**COUNTY OF SAN MATEO  
PLANNING AND BUILDING DEPARTMENT**

**SUBJECT:** EXECUTIVE SUMMARY: Consideration of a Design Review, Non-Conforming Use Permit, Use Permit, and Fence Height Exception, for an addition of a 962 square foot three-car attached garage, and 1,299 square foot first and second story addition, to an existing 2,432 sq. ft., non-conforming, single-family residence with a 9-foot 1-inch front yard setback on a 21,728 square foot parcel at 180 Lakeview Way in the Emerald Lake Hills area of unincorporated San Mateo County. Three significant trees are proposed for removal. A Non-Conforming Use Permit is required to allow a major addition to a non-conforming house; a Use Permit is required to allow three detached accessory buildings where one is the maximum, and a 1-foot right-side setback, where 3 feet is the minimum; and a Fence Height Exception is required to maintain the existing 6-foot-tall fence in the front yard.

County File Number: PLN 2020-00402 (Fang)

Figure 1: Site plan showing three existing detached accessory structures

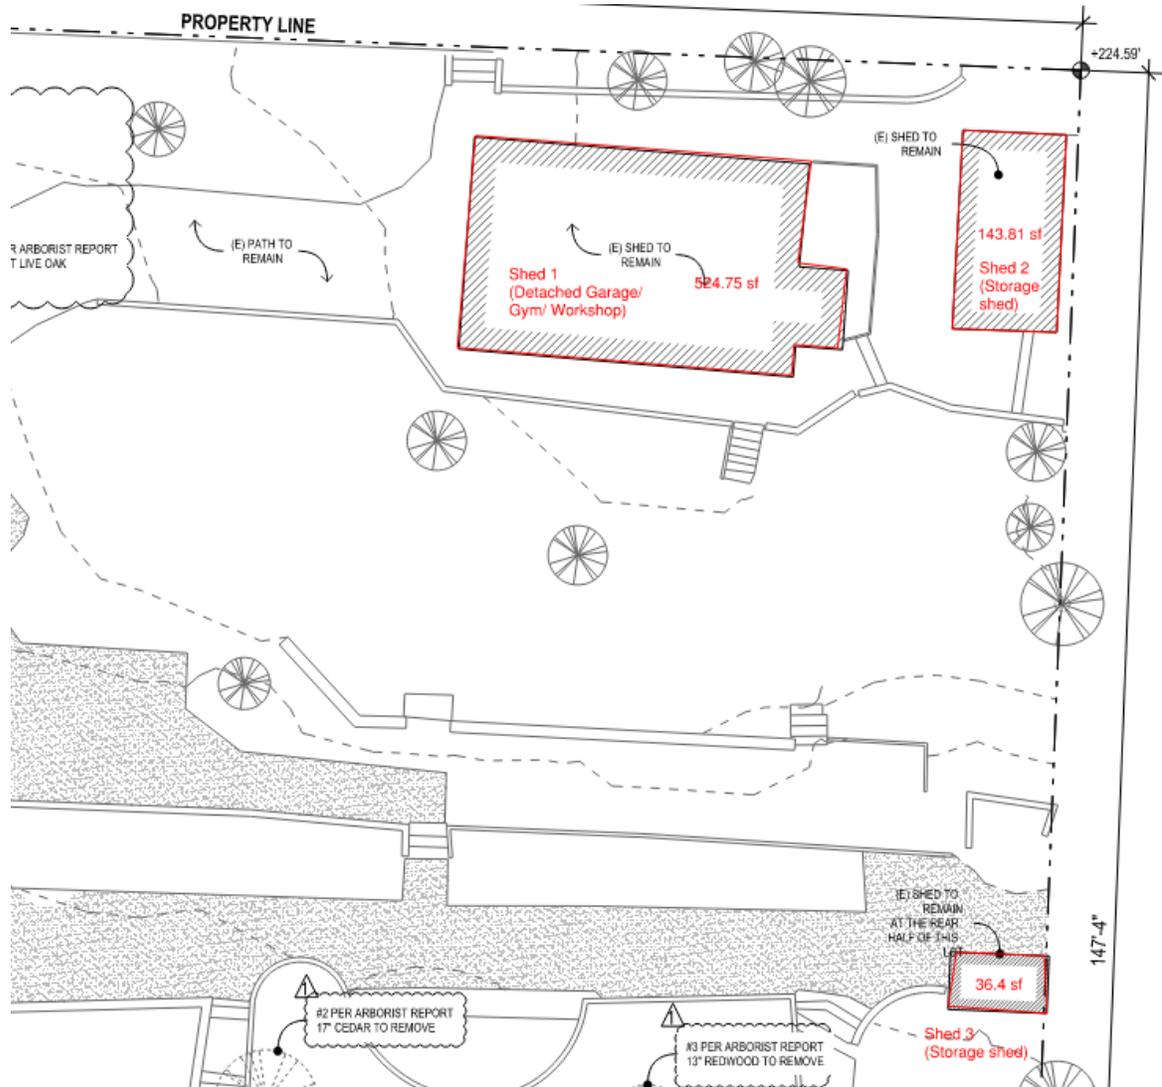
Section 6410 of the Zoning Regulations limits detached buildings to one, excluding a detached building providing required parking. The applicant requests to retain the detached garage/ workshop (shed 1) as it provides parking in excess of the County's parking requirements and is used as gym and workshop. This structure was approved through a previous planning application, PLN 2000-00607. The applicant also requests to retain shed 2 as it is used to store household items and kids' toys. This structure is built with a 1-foot side setback, whereas the minimum required side setback is 3-feet. While the applicant proposes to legalize a 3rd shed at the property, Staff supports retaining only two detached buildings at the property to maintain closer compliance with Section 6410. There is a fourth detached structure, a doghouse, that will be removed by the applicant before Building Permit final.

Shed 3 is a garden storage shed and is located in the first 50 percent of the lot. This shed is not in compliance with Section 6411 (b), and therefore, staff recommends removal of this structure. A Condition of Approval (Condition 7, Attachment A) has been added to allow two detached structures to remain (sheds 1 and 2) and to require removal of sheds 3 and 4, to keep the site in close compliance with the regulations.

Staff was not able to find associated building permits for sheds 1, 2, 3 and 4, and hence have added a condition (Condition 8, Attachment A) to require the applicant obtain building permits for all the detached accessory structures remaining on the site.

7. Only two detached accessory structures shall remain on site and the applicant shall remove sheds 3 (garden storage shed) and 4 (doghouse) prior to final of the building permit for the residence.

8. The applicant shall obtain building permits for all the detached accessory structures that will remain on the site.
9. The applicant shall show the revised location of front entrance stairs, as approved by the Department of Public Works on grading, drainage, and erosion control plan.

Figure 2: Proposed house materials

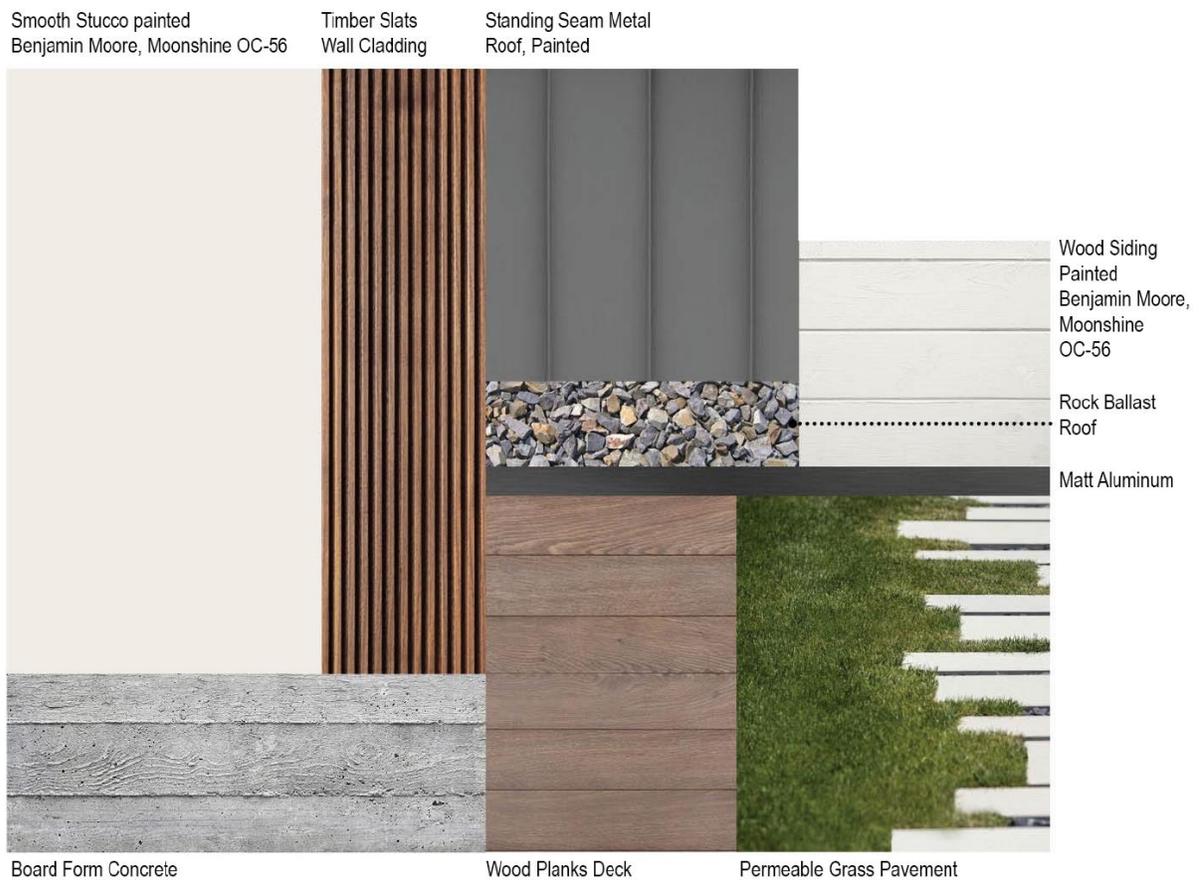
As proposed currently, the house has wood siding in beige color and the new addition will have smooth stucco painted in the same color. The existing house has horizontal wood siding and a composite shingle roof. The new addition will have a combination of materials- smooth stucco on the dining/living area walls and wooden slats on the walk-in-closet and jacuzzi portion of the addition.

At the hearing, the DRO required the applicant to modify the stucco color to more beige or light grey and paint the rest of the siding in the same color. The applicant revised the house color and agreed to paint the whole house in a singular color as shown below. A condition of approval (Condition 4, Attachment A) is added is also added to adhere to this requirement. Overall, the addition will be hidden behind the existing house and will not be visible from the street. At the August 10, 2021, Design Review Meeting the DRO reviewed the proposal and recommended approval of the project.

4. The applicant shall use a singular color for the whole house as shown in the submitted material board and approved by the Design Review Officer.
5. Materials (roof and exterior) shall be changed to improve the integration of the addition with the existing development. Changes made to the design to unify the addition shall be reviewed by the Design Review Officer prior to a final building permit sign-off by the Current Planning Section.

6. The approved exterior colors and materials shall be verified prior to final approval of the building permit. The applicant shall provide photographs to the Design Review Officer to verify adherence to this condition prior to a final building permit sign-off by the Current Planning Section.
